PERCOLATION TESTING

SUBDIVISION (Agnes L. Linthicum Subdivision) *Linthicum Oaks II* LOT NO. 2

JOB LINTHICUM OAKS
 SHEET NO. SECOND TRACT OF _____
 CALCULATED BY _____ DATE 3/3/05
 CHECKED BY SANDMOUNA DATE _____
 SCALE _____

DATE	<u>5/31/05</u>	JOB NO.	
ATTENTION	<u>KEVIN BELL</u>		
RE:	<u>SECOND TRACT</u>		
	<u>LINTHICUM HEIGHTS</u>		
	<u>EFFLUENT PUMP</u>

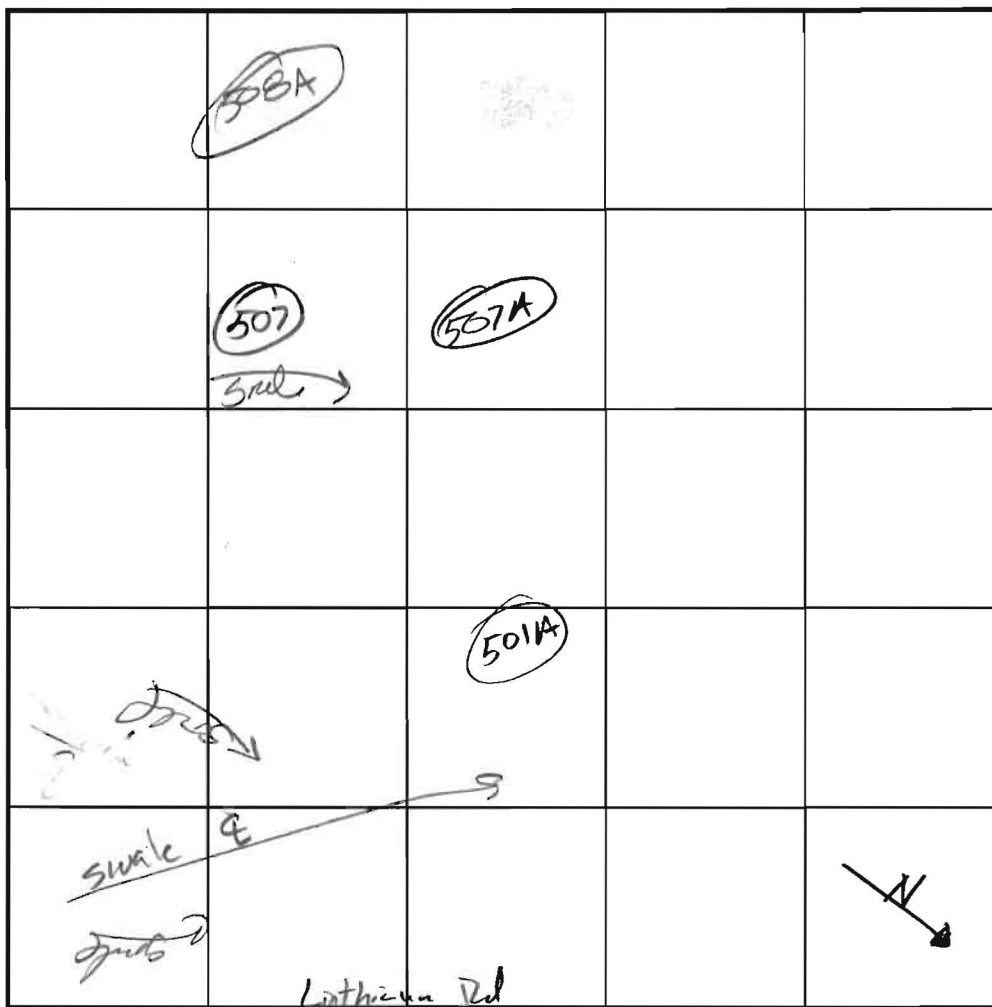
DATE	TEST NO.	DEPTH	PRE-WET		TEST - 1" DROP		TIME
			START	STOP	START	STOP	
6/12/03	501A	3V					F
	507A	3 1/2 V					F
	507	4 1/2 V	possible sand mound; need plan				H
	508A	8 1/2 V	possible sand mound; need plan				H

REMARKS 2003 w.s. test pits to verify water table

ME Series 1/2 through 1-1/2 HP Effluent Pumps Performance Curve

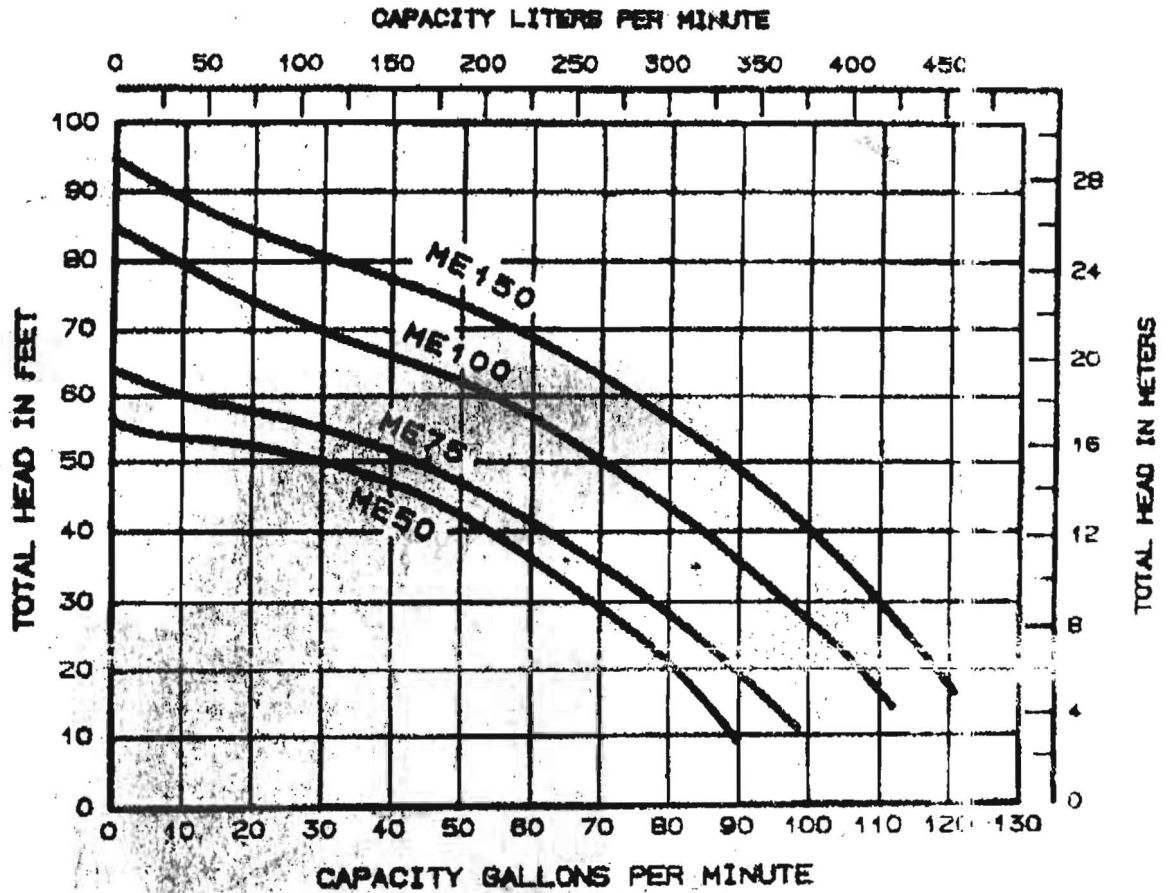
REMARKS KEVIN - I HAVE REVIEWED THE CALCULATIONS IN
LIGHT OF BARRY GLOFFECTYS CONCERN. THE
GOULDS WE-7-H SPECIFIED SHOULD BE ADEQUATE,
BUT JUST BARELY.
TO REMOVE ANY CONCERNS I HAVE CHANGED THE
SPECIFICATIONS TO SPECIFY A GOULDS WE10-H -
1 H.P.

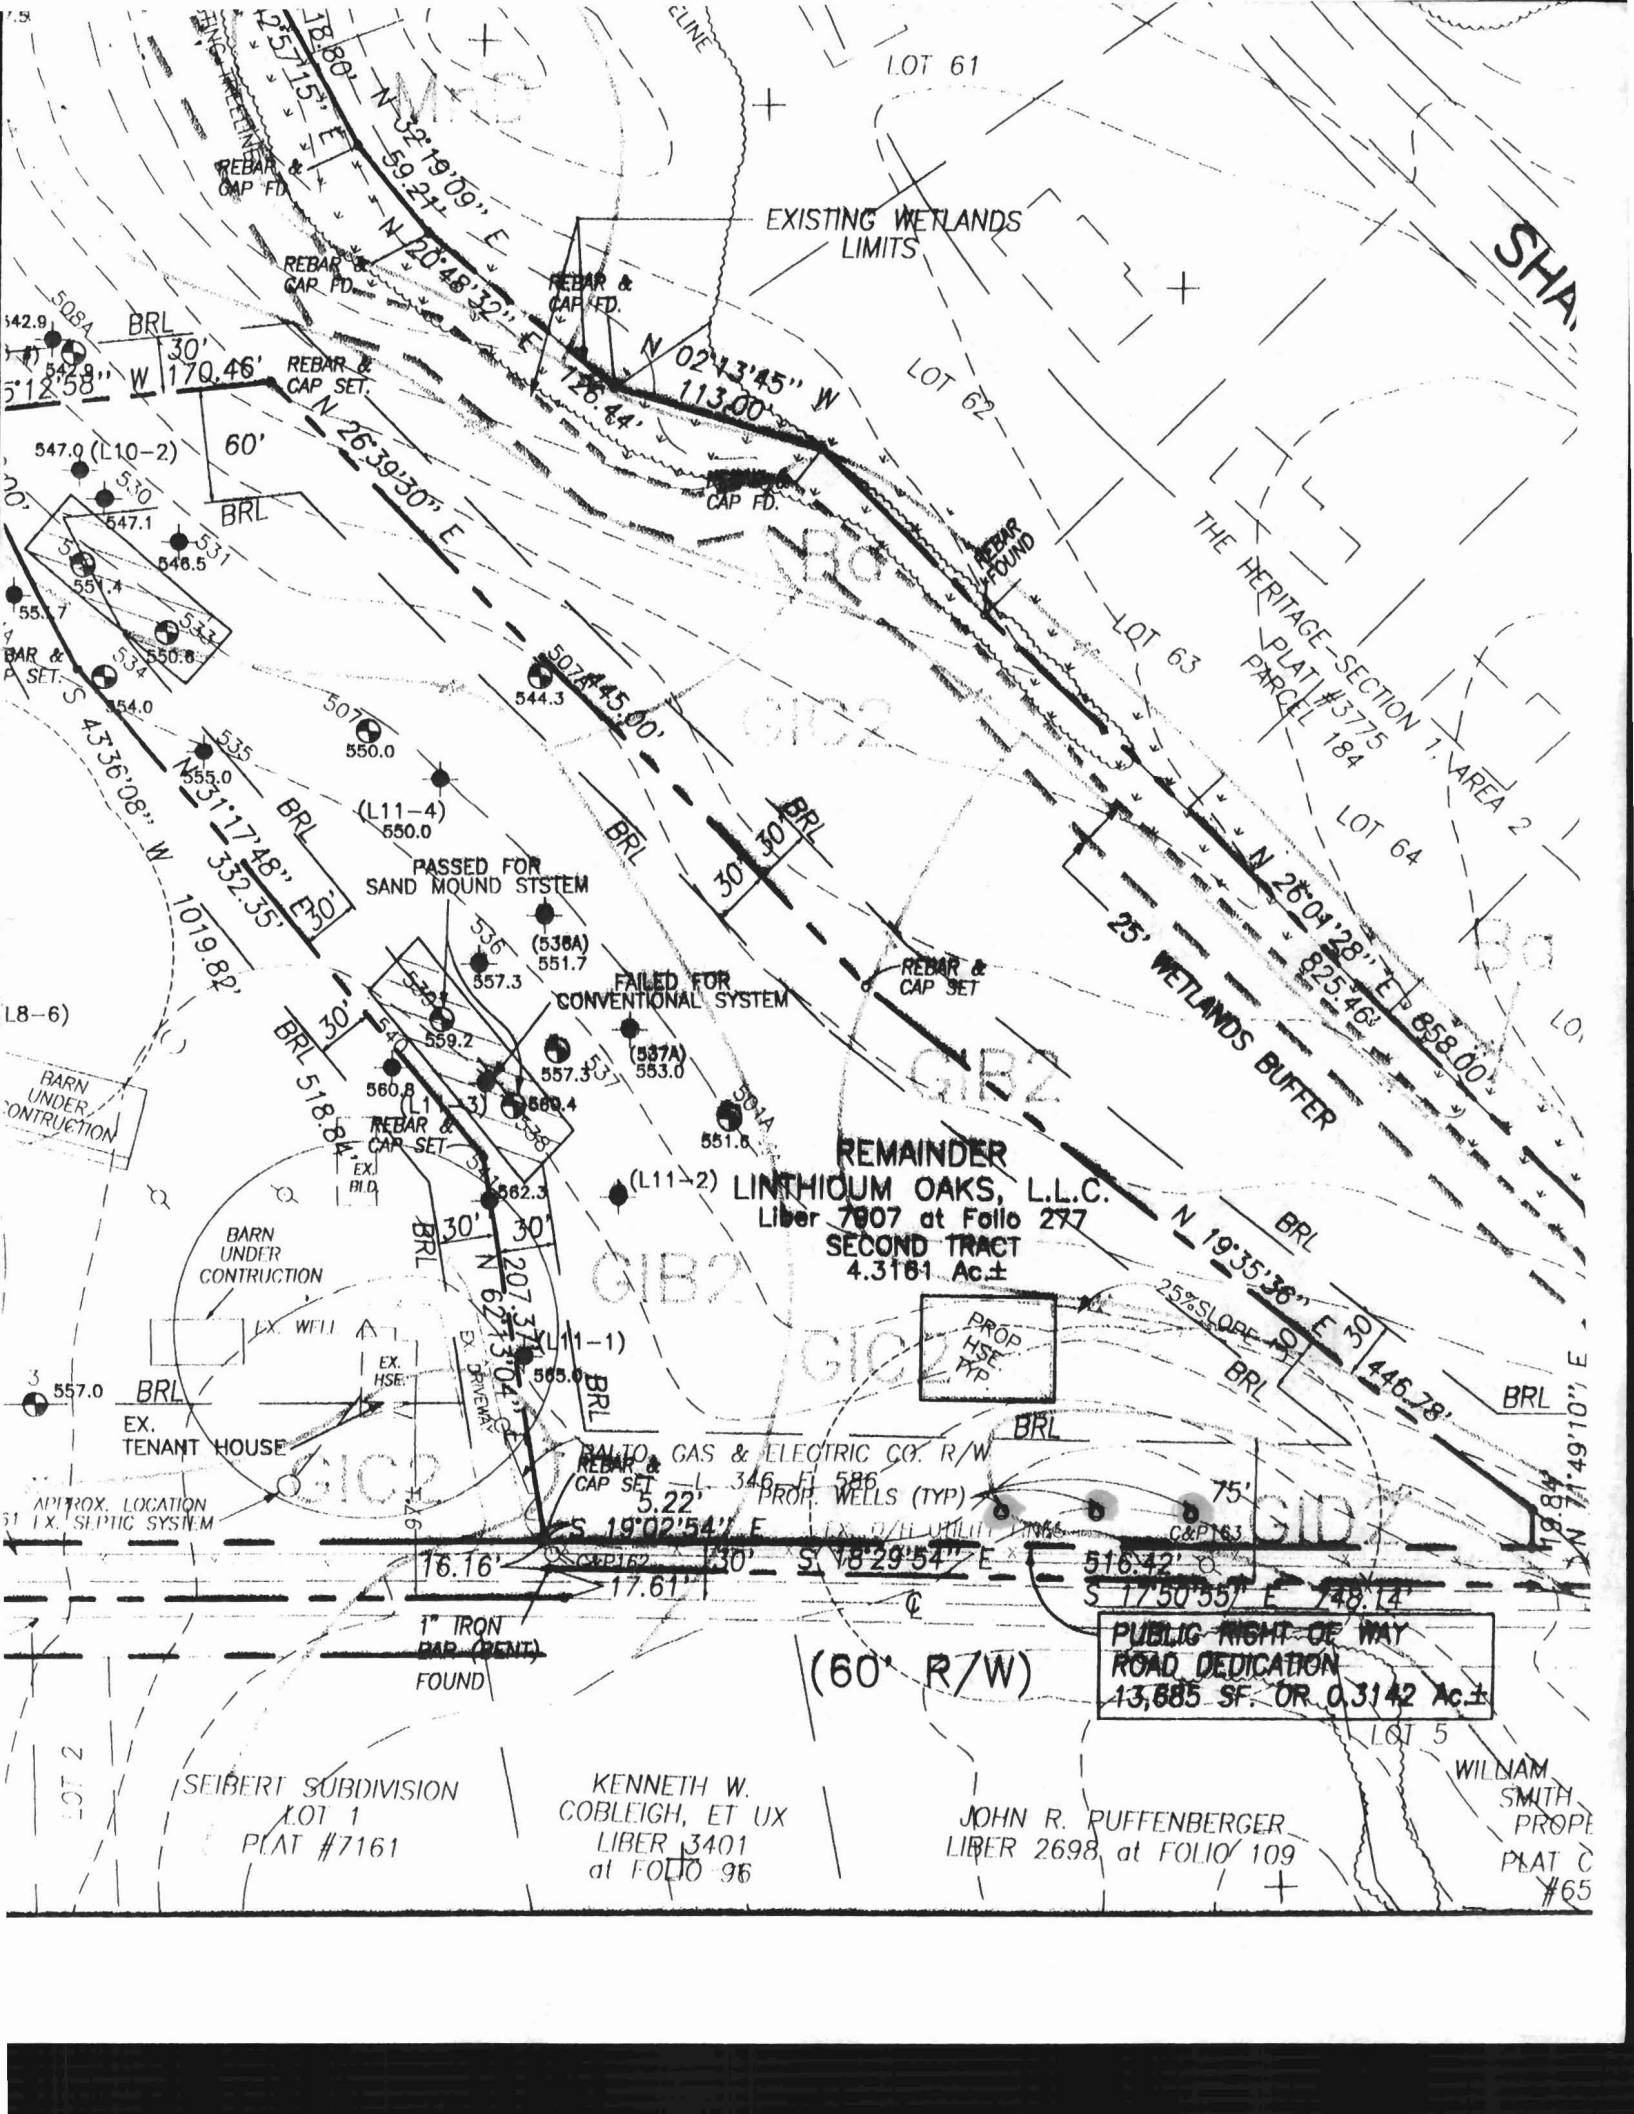
I spoke w/ the Mr and told them
to move the mound site away from
proposed driveway of 1415 453
